# **Access Arrangement Review Multinet (MGN)**

*Date 24 November 2022*

*Zincara P/L*

**Figure 4-1: Distribution mains leak incident rate by material**

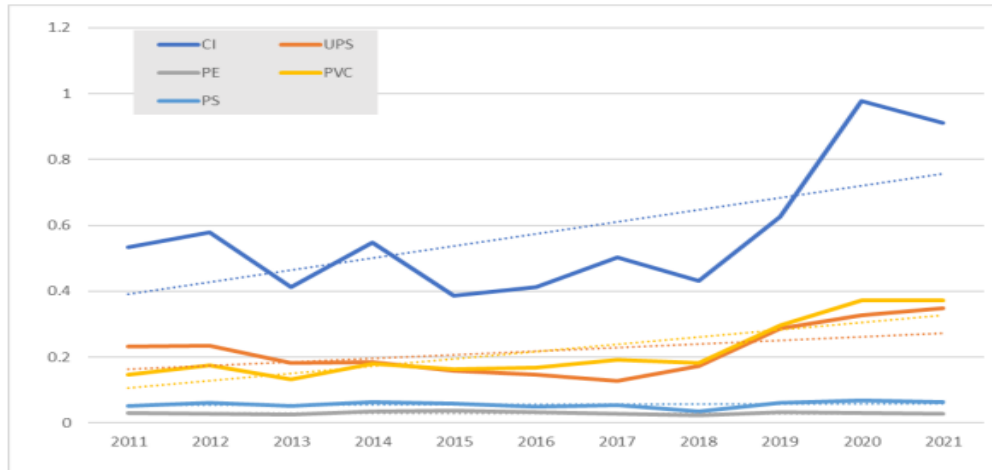
The above figure shows leaks<sup>13</sup> per kilometre by material type. This shows that cast iron experiences a relatively higher rate of leaks and is the major contributor to the poor low pressure network condition, followed by unprotected steel and PVC. It is noted that PVC is only found in the low pressure networks. These three material types constitute over 94% of the low pressure network.

With respect to cast iron leakage rate, during the previous AA review (2017) a similar figure showed a reducing trend from 2005 to 2015. This current figure shows a relatively flat trend up to 2018 and then the leak rate increasing to 2020, with 2021 then being a similar rate.

In response to IR020, requesting information relating to the upturn in leak incident rates for cast iron, unprotected steel and PVC since 2018, MGN advised that it is likely driven by a combination of factors:

MGN also noted in its IR020 response that *“regardless of historic leak rates, a leak incident rate of 0.4-0.6 is 20-30 times the rate of polyethylene materials and represents a significant number of potentially fatal risk events each year across our networks. This has been the driver for the proactive replacement of these mains across Australia for the last two decades”*.

**Figure 4-2: Leak history of remaining low pressure mains (excluding leak survey)**

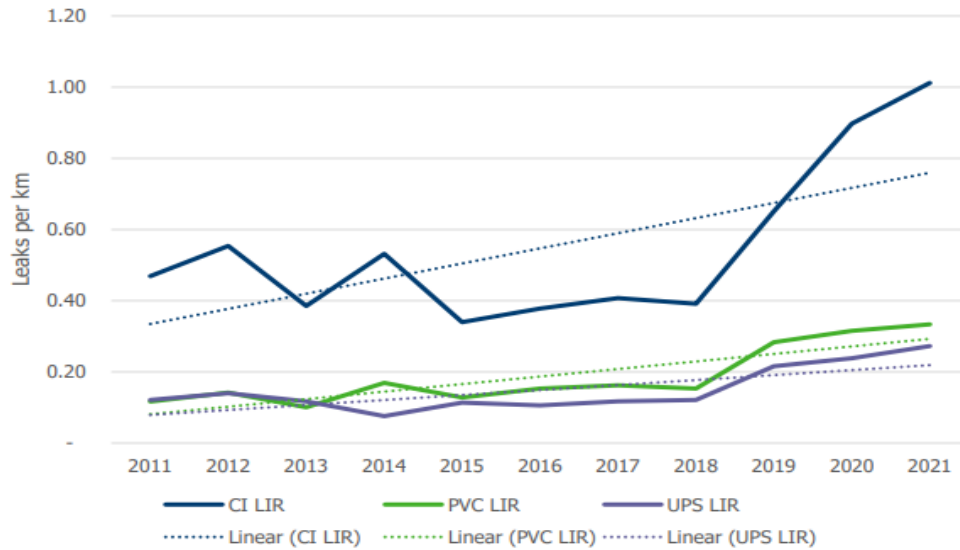
The above figure does confirm that the remaining low pressure assets are continuing to deteriorate, with each of the material types showing increasing trends of the leakage rate, particularly over the last few years.

**Figure 4-3: Cast iron fracture incident rate over time**

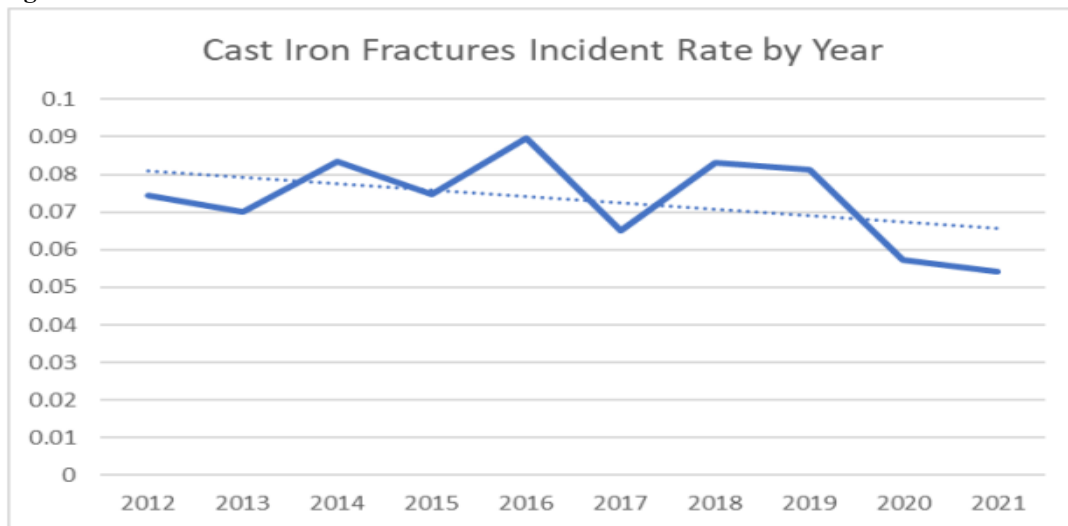
The above figure shows the number of fractures per kilometre of cast iron mains. This is known as the fracture incident rate (FIR). MGN has stated<sup>14</sup> that "the FIR had been increasing over the 2001 to 2015 period and as a result they switched to a prioritised replacement and

abandonment of areas with a high FIR. The result is reflected in the decreasing FIR over recent years”.

**Figure 4-4: Fracture incident rate on remaining low pressure mains ( excluding leak survey)**

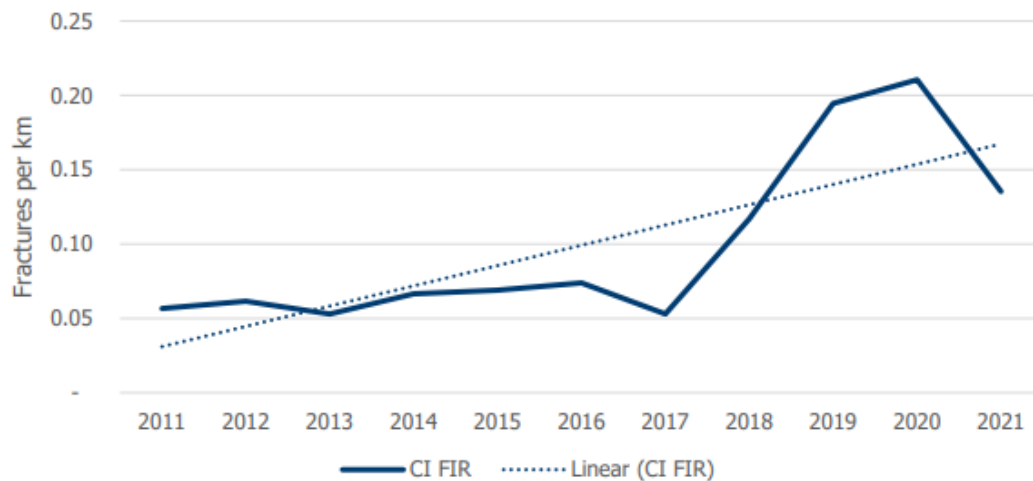
Following a request for information specifically relating to the FIR history of remaining cast iron mains MGN has provided the following figure which shows that there is an increasing trend particularly over the last few years, further indicating that remaining mains are continuing to deteriorate .

**Figure 4-8: Leaks and breaks on early generation PE mains by age (excluding leak survey)**

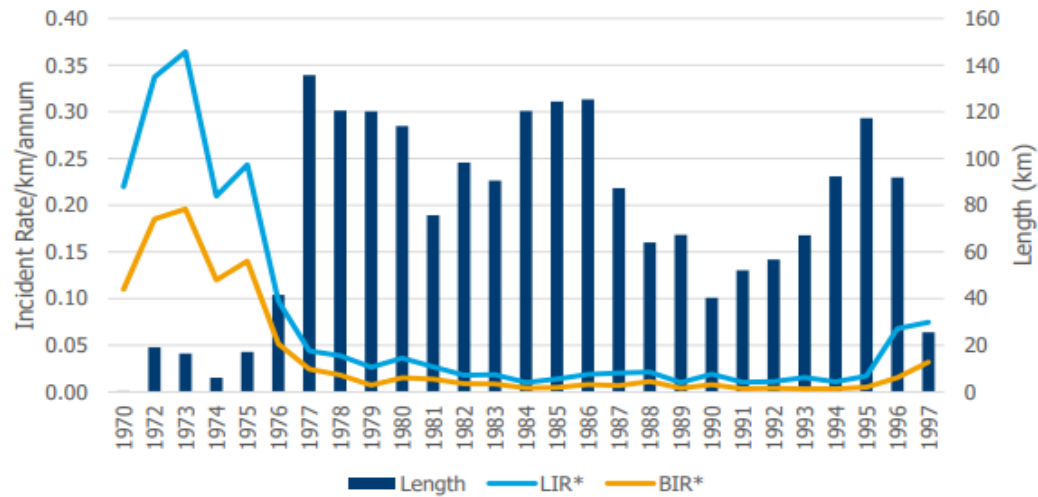
The above figure shows that the oldest PE mains have experienced significantly greater incident rates of leaks and fractures than the newer PE mains. The FIR for the oldest PE mains in particular is at a level higher than reported for many of the low pressure mains replacement postcodes.

**Figure 4-9: Early generation HDPE volumes by construction year**

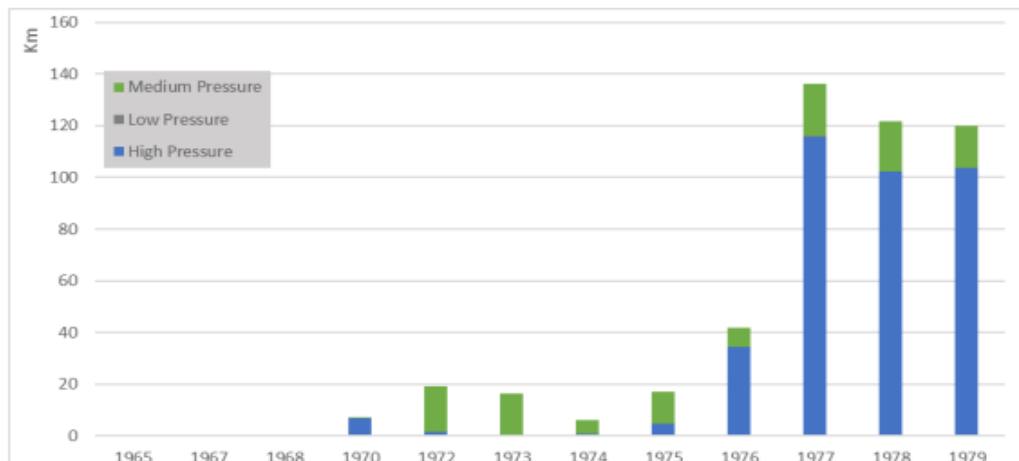
The above figure of volumes by pressure and age shows that mains laid in 1972 to 1975 were almost exclusively medium pressure. Comparing the two figures indicates that the old

medium pressure PE mains have the highest rate of leaks and fractures. This analysis supports the view that the old medium pressure PE mains are likely to be in poorer condition compared to the newer PE mains. MGN says<sup>27</sup> that it is these mains that they are targeting for replacement during the next AA period. Spatial maps included in MGN’s Distribution Mains Strategy (section 4.4), dated December 2016, confirm the location of the oldest PE mains being in the xxxx and xxxx area. The maps also show location of leaks and fractures.
